1 DEFERRED COMMENCEMENT

1.1.1 This development consent is not to operate until such time as the applicant has submitted amended plans to Council's town planning department for separate approval, which address the following matters:

client: residential apartments + basements
 project: 1-11 olive street, SEVEN HILLS
 title: basement 3 plan

Image 1: Olive Street elevation - 20 metre height shown in blue (Source: GM Architects)

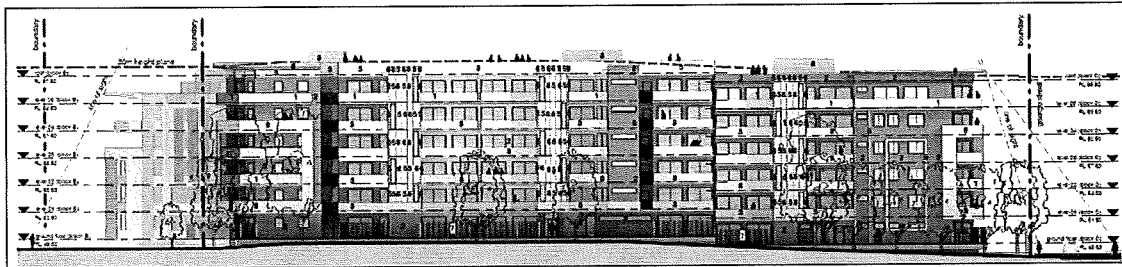
The portion of the building that is above the height control is illustrated in the following section plan from the architectural plans prepared by GM Architects.
